CITY OF NEWTON
Department of Public Works
ENGINEERING DIVISION

MEMORANDUM

Re: Special Permit – #131 Charlesbank Road

*Proposed Addition
131 Charlesbank Road
Newton, MA
Prepared by: Hayes Engineering
Dated: April 10, 2015
Revised: April 14, 2015*

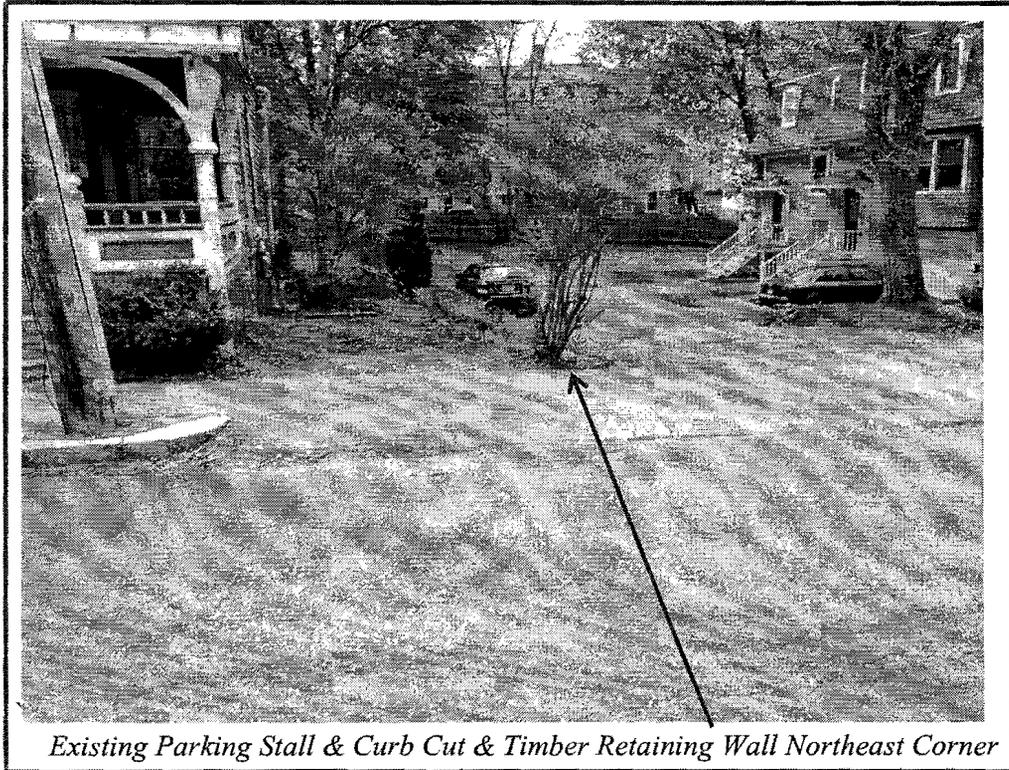
Based on a site visit yesterday an existing parking area is located on the northeast corner of the lot (see photo below); clarification is needed regarding this stall; is it to be removed and the driveway apron will be modified or is the intent to keep the stall? Ownership and future status of the landscape timber retaining wall shown as a bold black line on the site plan needs clarification. The site plan refers to various notes on Sheet 2; however no Sheet 2 was submitted.
